RS-13-157

Clinton Power Station, Unit 1  
Facility Operating License No. NPF-62  
NRC Docket No. 50-461

Subject: Response to Request for Additional Information - Overall Integrated Plan in Response to Commission Order Modifying License Requirements for Reliable Spent Fuel Pool Instrumentation (Order No. EA-12-051)

1. Clinton Power Station, Unit 1- Response to Request for Additional Information - Overall Integrated Plan in Response to Commission Order Modifying License Requirements for Reliable Spent Fuel Pool Instrumentation (Order No. EA-12-051)

Elevation or Side View

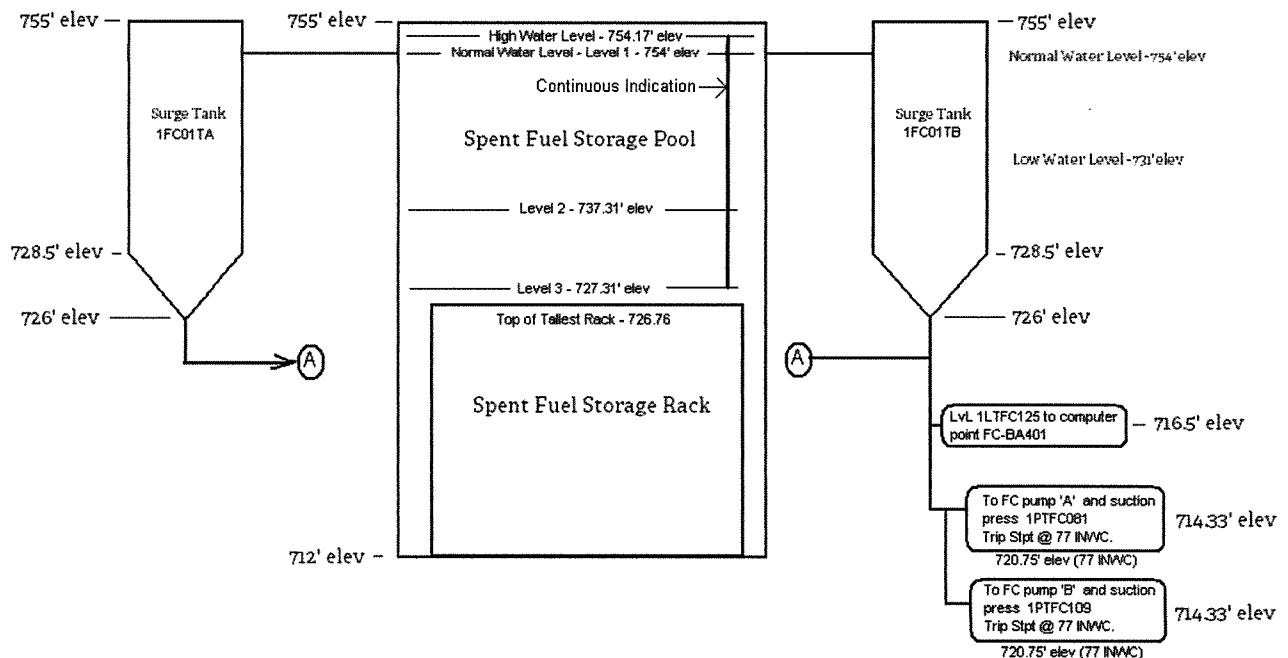
- a) For Level 1, specify how the identified location represents the higher of the two points described in the NEI 12-02 guidance for this level.

- b) A clearly labeled sketch depicting the elevation view of the proposed typical mounting arrangement for the portions of instrument channel consisting of permanent measurement channel equipment (e.g., fixed level sensors and/or stilling wells, and mounting brackets). Indicate on this sketch the datum values representing Level 1, Level 2, and Level 3 as well as the top of the fuel. Indicate on this sketch the portion of the level sensor measurement range that is sensitive to measurement of the fuel pool level, with respect to the Level 1, Level 2, and Level 3 datum points.

- a) The Spent Fuel Pool at Clinton Power Station has skimmers and scuppers located at the 754' elevation that water must flow into. From there the water is routed to surge tanks from which the Fuel Pool Cooling and Cleanup (FC) pumps draw suction. The suction trip is at an approximate 720.75' elevation. Thus the 754' elevation reflects the higher of the two points noted in NEI 12-02, Section 2.3.1.
- b) The sketch showing the description above is as follows. Instrument probe mounting details in the Spent Fuel Pool area will be provided in accordance with the response to RAI-3.
